ARCHITECTURAL PLANS ARE WERE PREPARED BY OTHERS. CIVIL AND STRUCTURAL ENGINEERING SERVICES PROVIDED STRUCTURAL ENGINEERING DESIGN REVIEW SERVICES. THE PROFESSIONAL SEAL AND SIGNATURE AFFIXED BELOW CERTIFY THAT PLANS AS MARKED/NOTED MEET LOAD BEARING REQUIREMENTS OF NORTH CAROLINA BUILDING CODE, **RESIDENTIAL 2018**

000	Cover						
001 Notes							
101-A First Level Arch. Plan							
101-S First Level Struct. Plan 201 Sebedules							
201Schedules301Elevations							
301 Elevations 302 Elevations							
401	Foundation Layout						
501	Panel Layout						
601	Roof Framing Layout						
701	Building Sections						
702	Building Sections						
703	Wall Sections						
704	Wall Sections						
705	Details						
No	Description	Doto					
No. 0	Description Initial Plans	Date 5.4.22					
	Release	5.18.22					
Evans							
Ridgeline - B South							
Job Number 22031							
Drawing Number 22RI-098							
Project Manager SG							
Drafter JC							
Cover							
000 Scale

Ridgeline - B South

No. 0 1	Description Initial Plans Release	Date 5.4.22 5.18.22
	Evans	
	Ridgeline - B South	
Drawi	Job Number22031Drawing Number22RI-098Project ManagerSG	
Drafte	Drafter JC	
	Foundation Layout	
	401

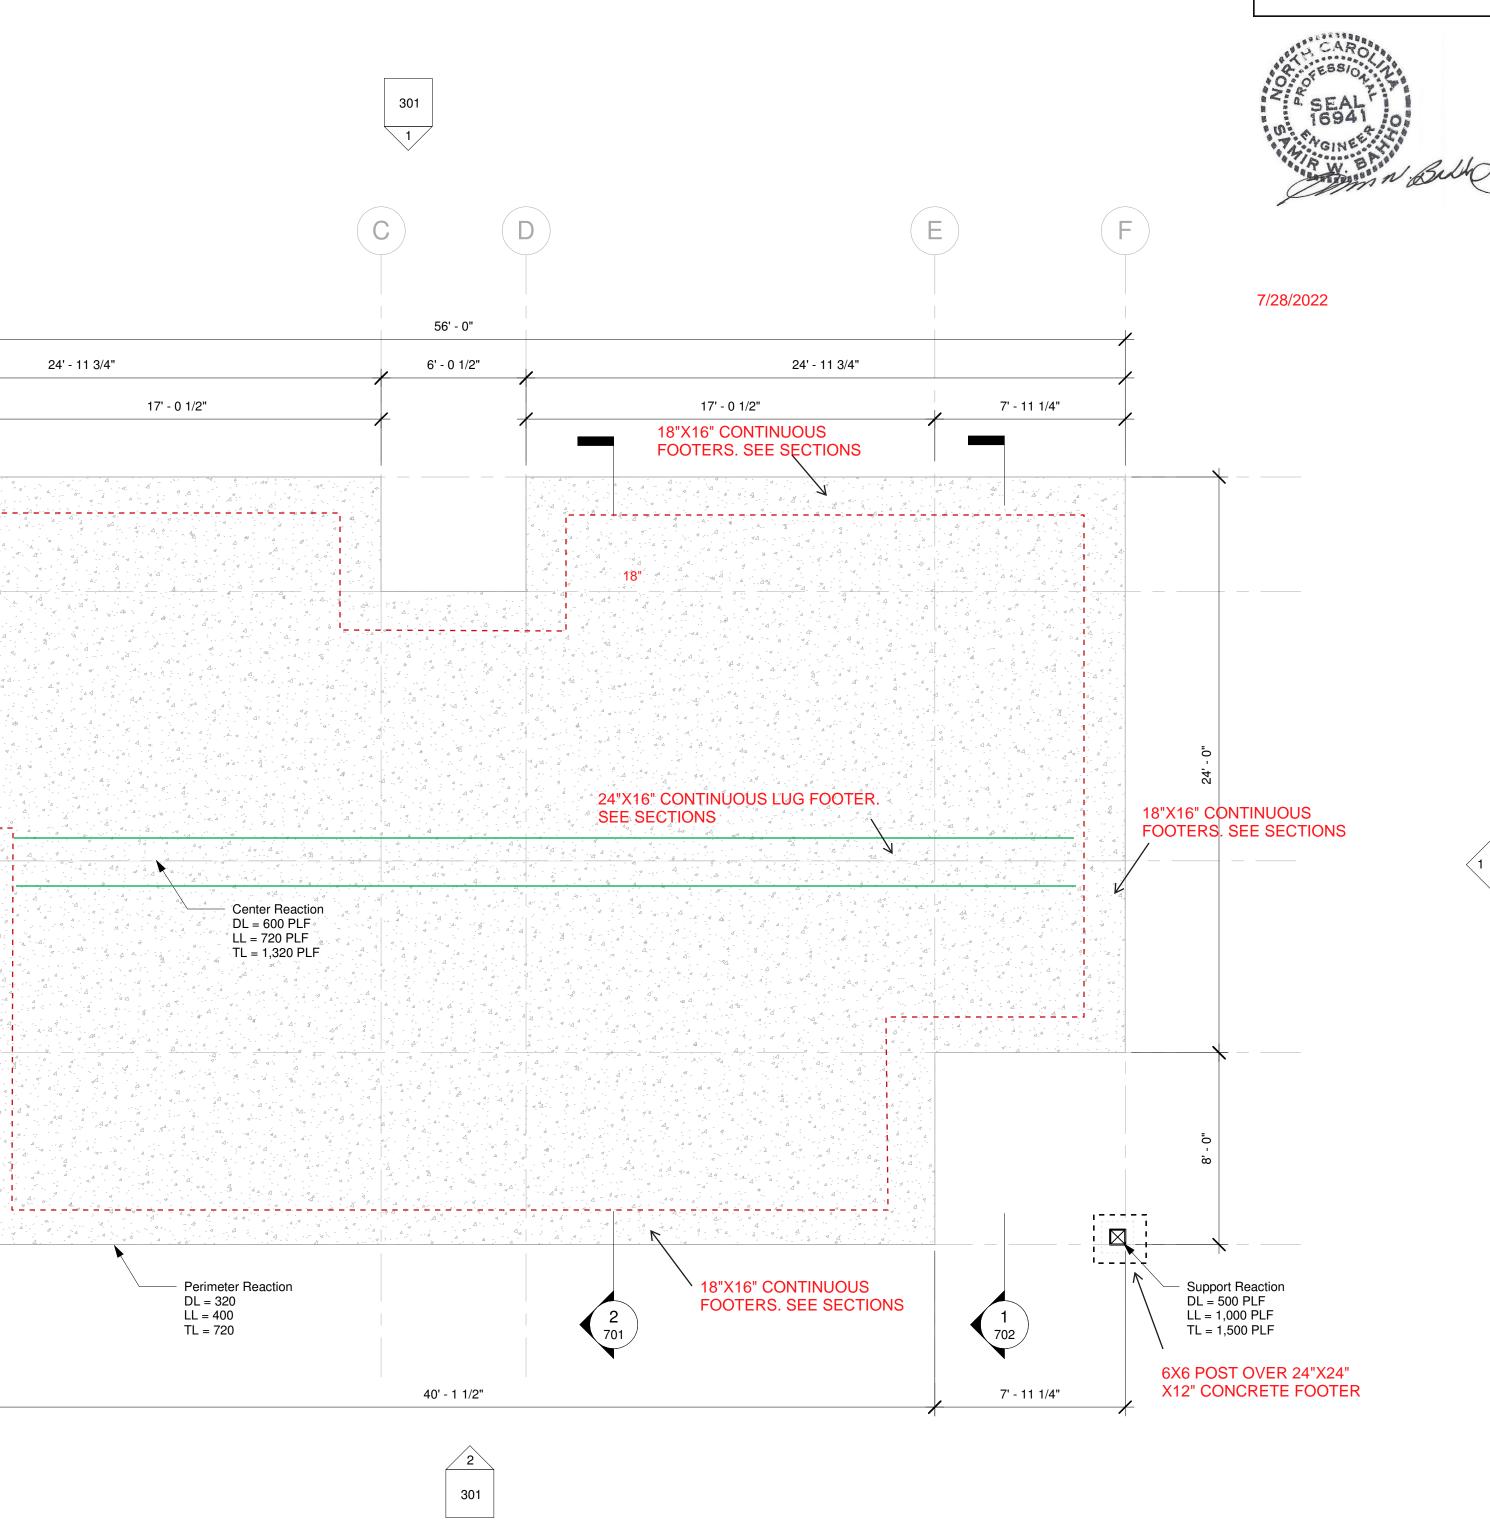
NOTE: FOUNDATION SLAB SHALL BE CONSTRUCTED AS FOLLOWS: 4" CONCRETE SLAB 3000 PSI STRENGTH WITH FIBERGLASS REINFORCEMENT OVER MIN 6 MIL VAPOR BARRIER OVER 4" WASHED CRUSHED STONE 67 OVER MECHANICALLY COMPACTED EARTH. VIRGIN UNDISTURBED SOIL SURFACE IS ACCEPTABLE

NOTE: FOOTERS SHALL BE CONTINUOUS ALONG THE OUTSIDE PERIMETER OF THE SLAB. DIMENSIONS OF FOOTERS SHALL BE AS SHOWN ON THE PLAN SECTIONS. FIBERGLASS CONCRETE WITH 3000 PSI STRENGTH IS PERMISSIBLE.

Wall Sections

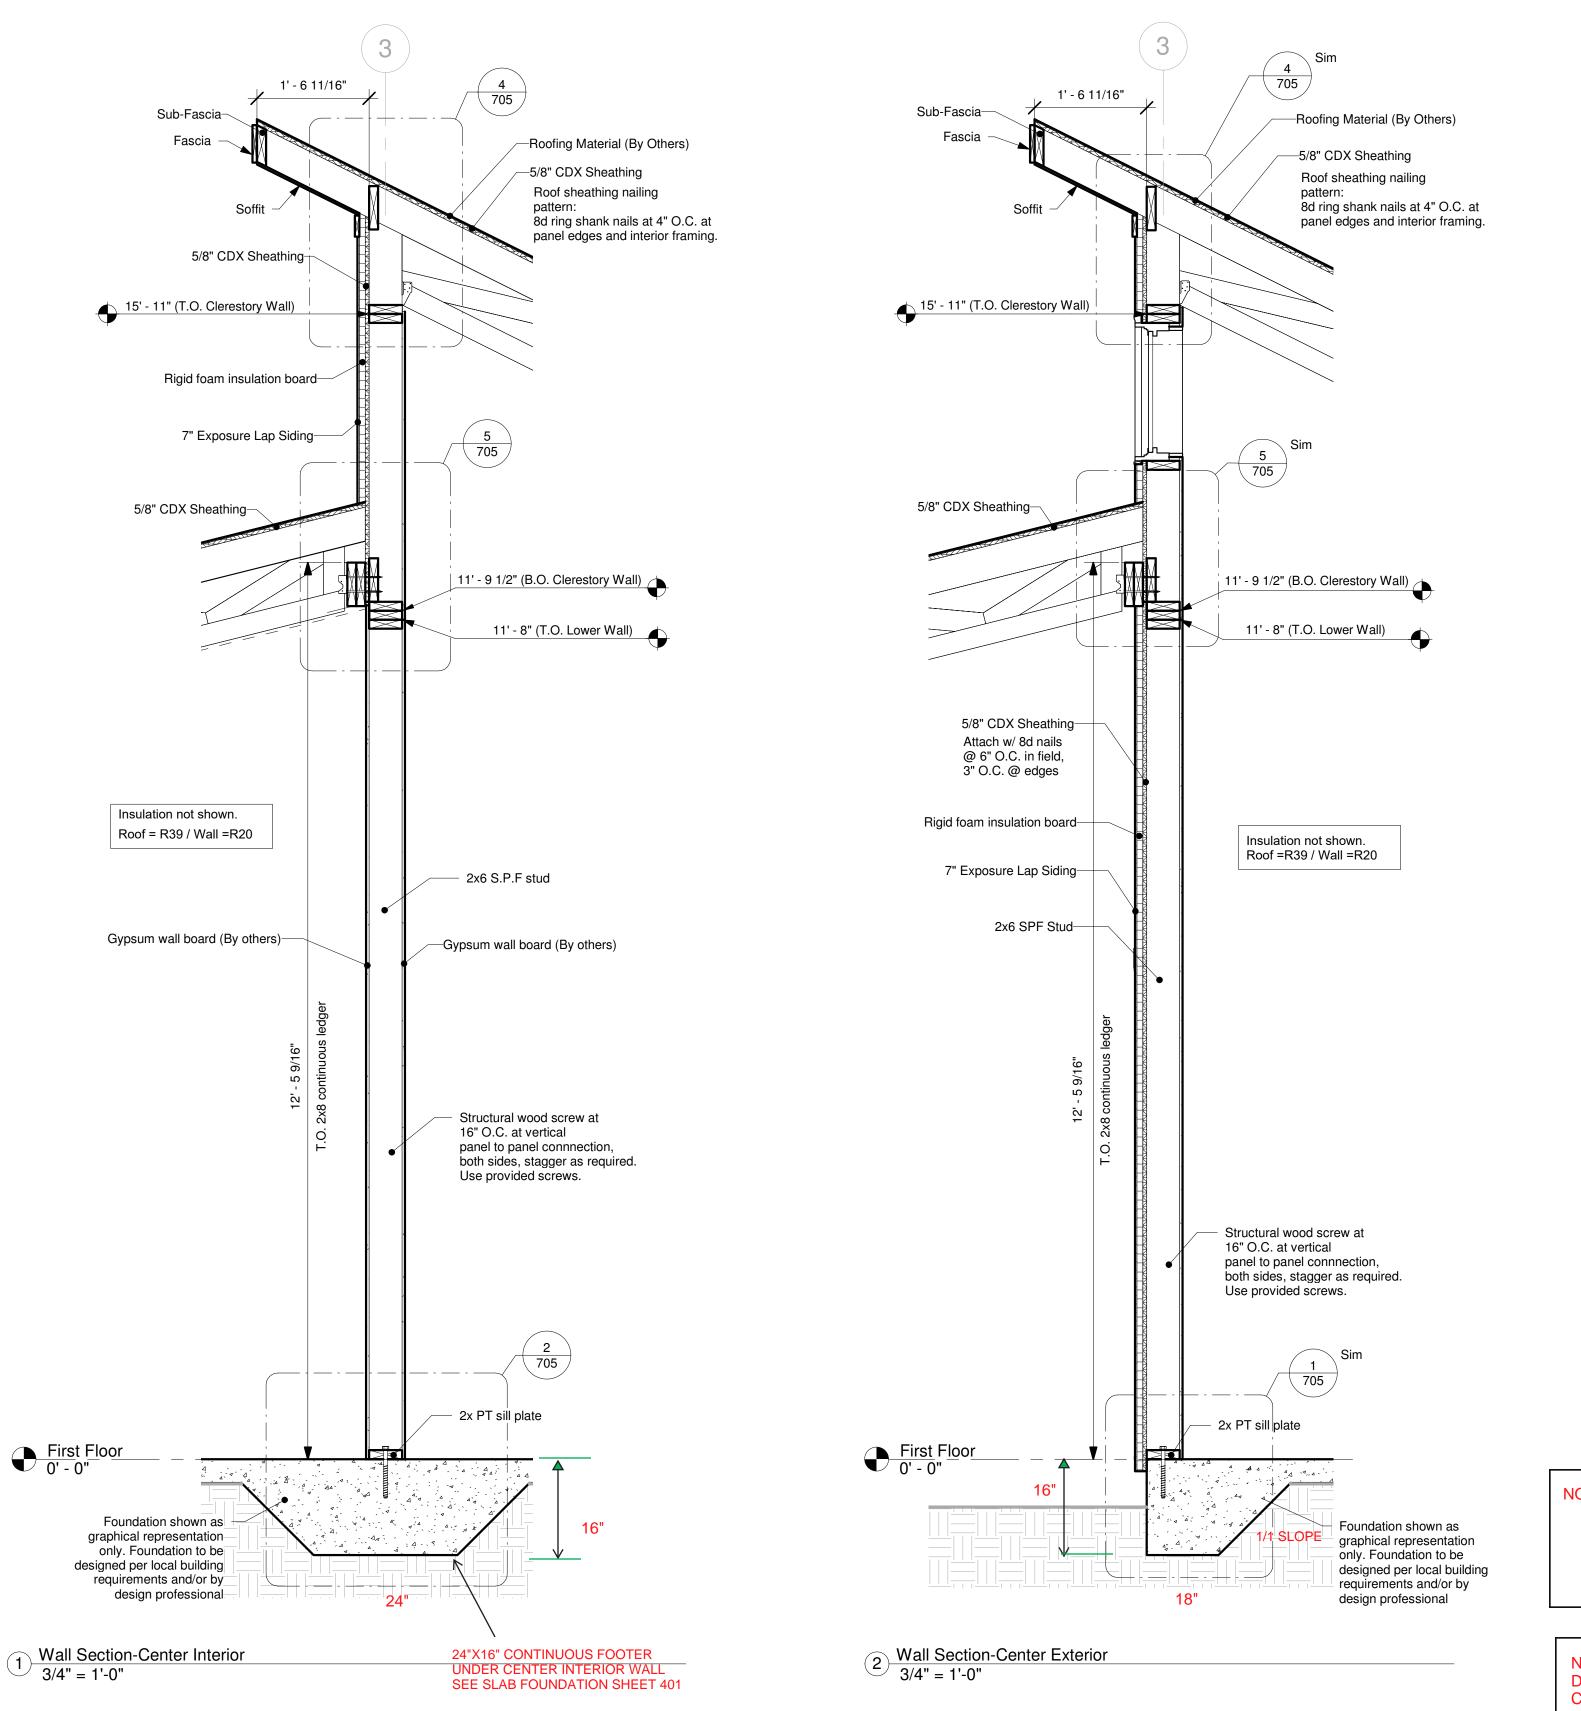
NOTE: FOUNDATION SLAB SHALL BE CONSTRUCTED AS FOLLOWS: 4" CONCRETE SLAB 3000 PSI STRENGTH WITH FIBERGLASS REINFORCEMENT OVER MIN 6 MIL VAPOR BARRIER OVER 4" WASHED CRUSHED STONE 67 OVER MECHANICALLY COMPACTED EARTH. VIRGIN UNDISTURBED SOIL SURFACE IS ACCEPTABLE

NOTE: FOOTERS SHALL BE CONTINUOUS ALONG THE OUTSIDE PERIMETER OF THE SLAB DIMENSIONS OF FOOTERS SHALL BE AS SHOWN ON THE PLAN SECTIONS. FIBERGLASS CONCRETE WITH 3000 PSI STRENGTH IS PERMISSIBLE.

NT	deltec homes
	No. Description Date
	No.DescriptionDate0Initial Plans5.4.221Release5.18.22
	Evans
	Ridgeline - B South
	Job Number22031Drawing Number22RI-098Project ManagerSGDrafterJC
	Wall Sections
	704

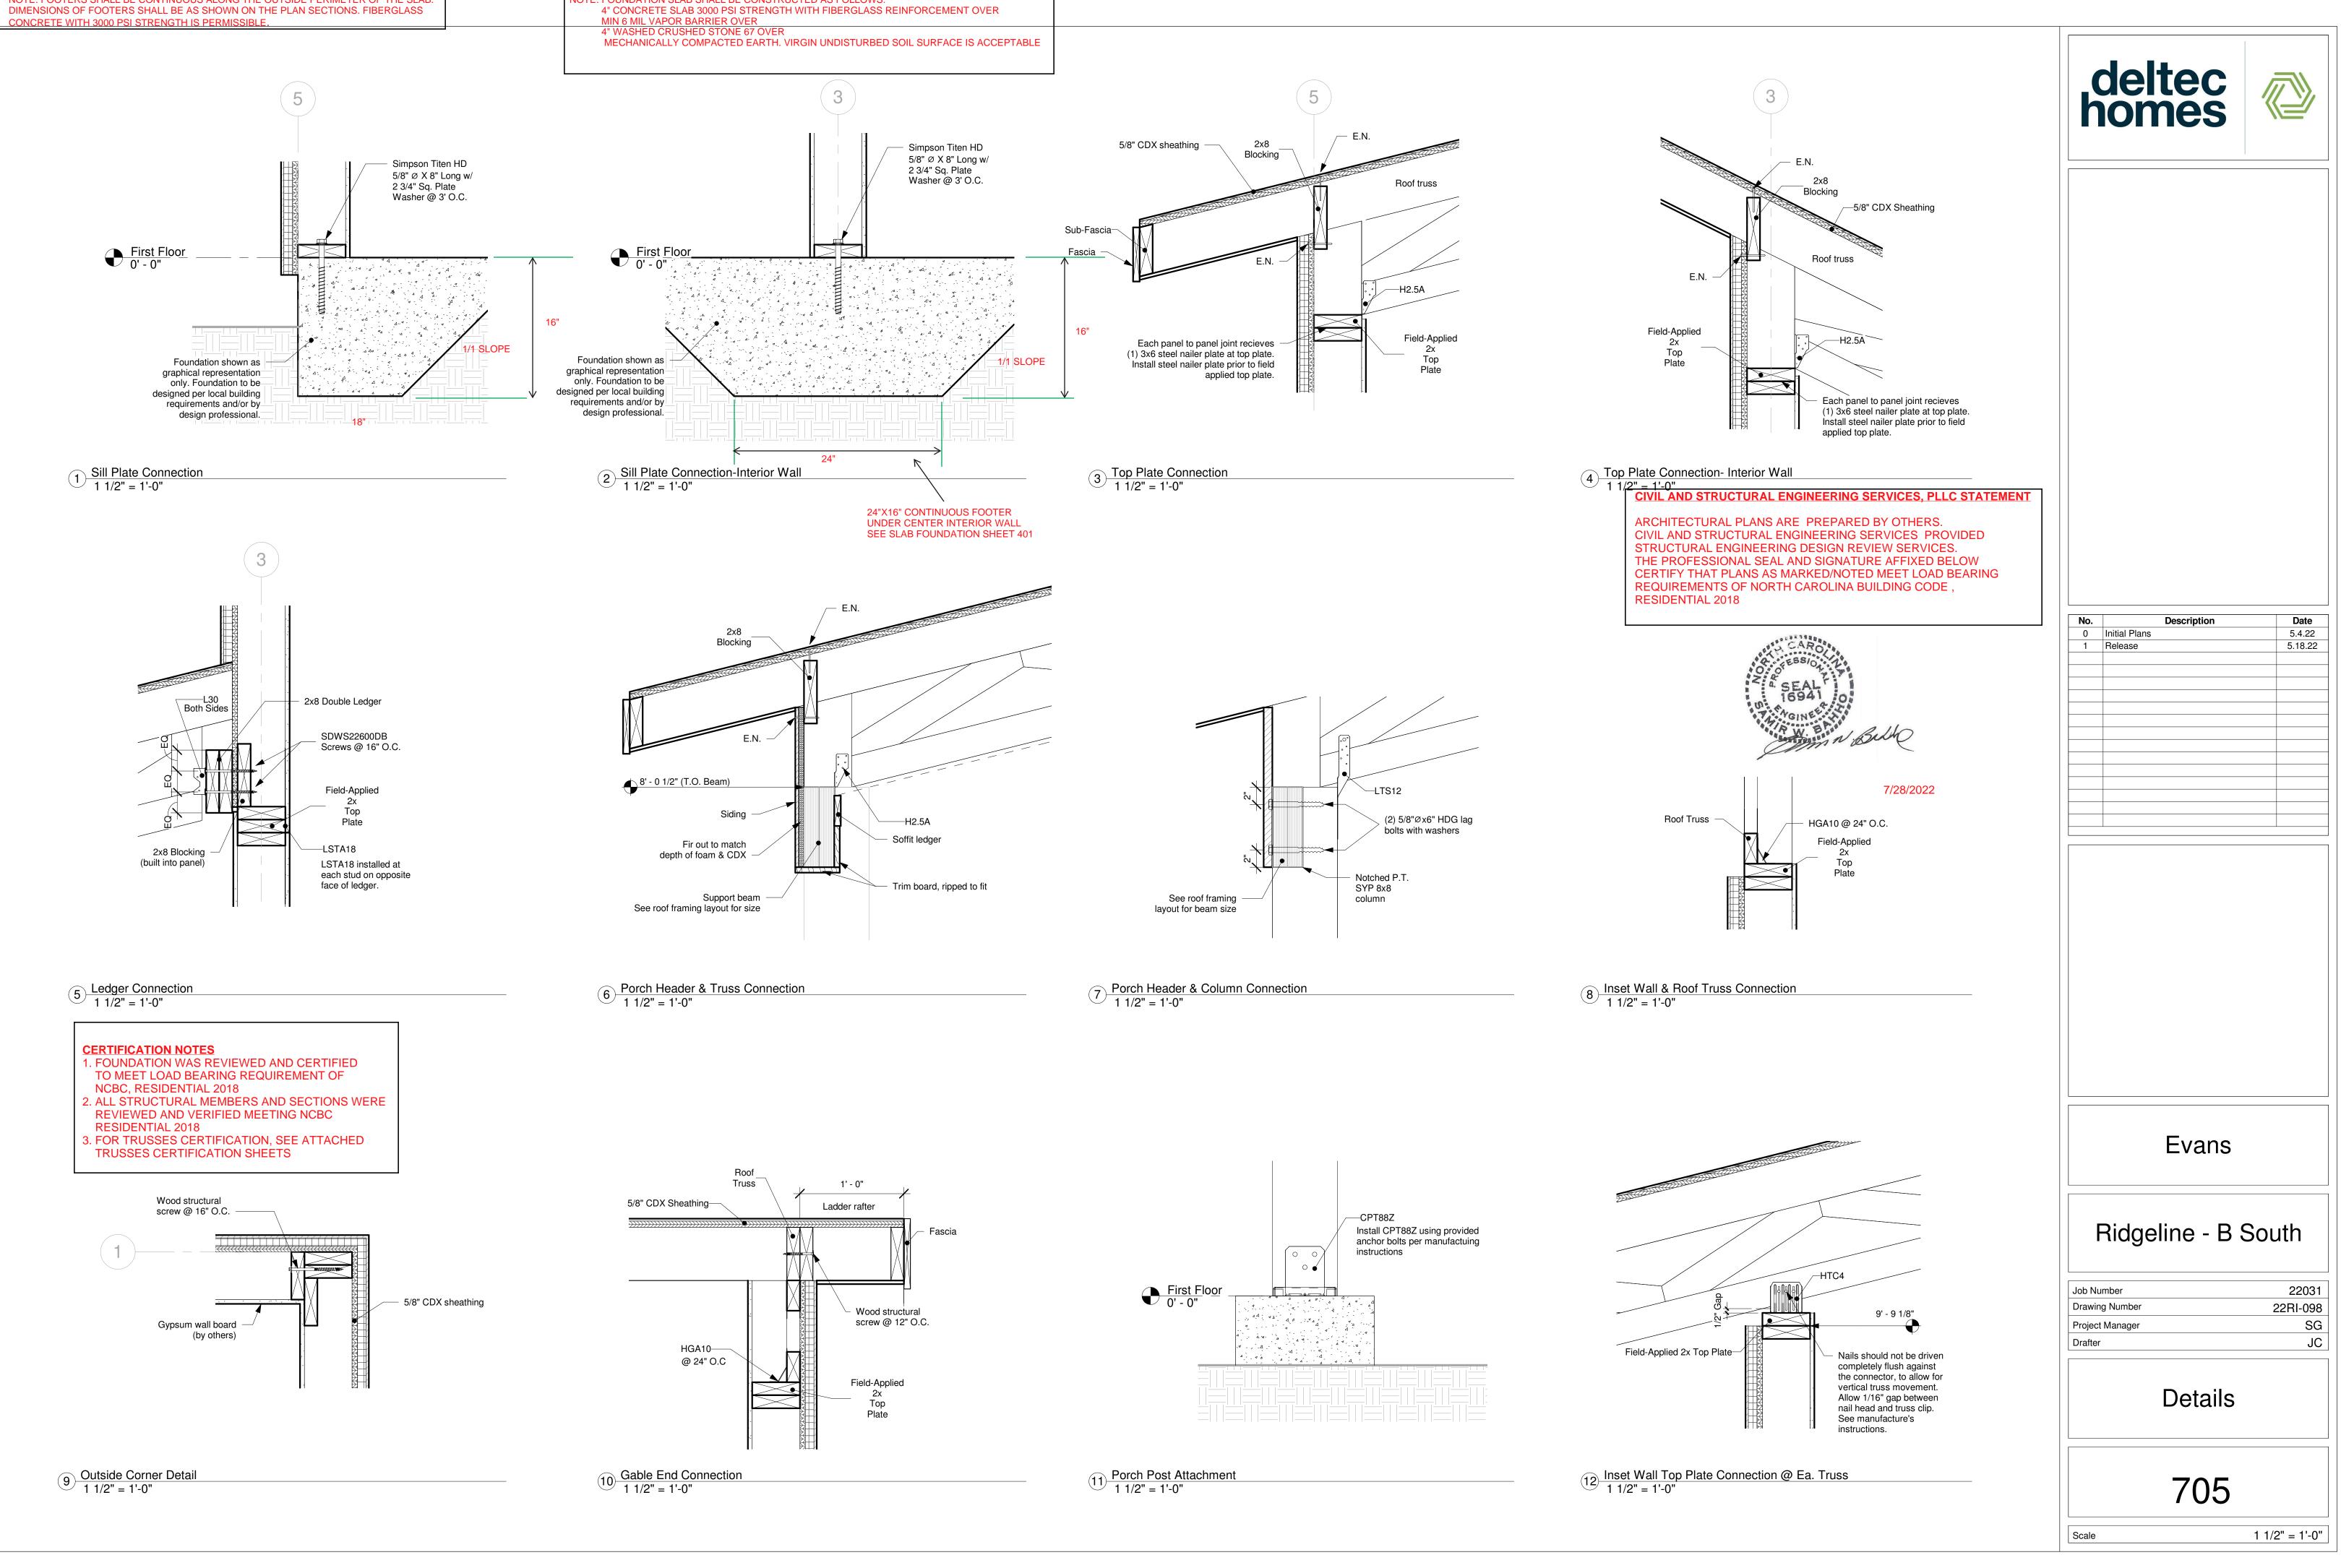
NOTE: FOOTERS SHALL BE CONTINUOUS ALONG THE OUTSIDE PERIMETER OF THE SLAB. DIMENSIONS OF FOOTERS SHALL BE AS SHOWN ON THE PLAN SECTIONS. FIBERGLASS

NOTE: FOUNDATION SLAB SHALL BE CONSTRUCTED AS FOLLOWS:
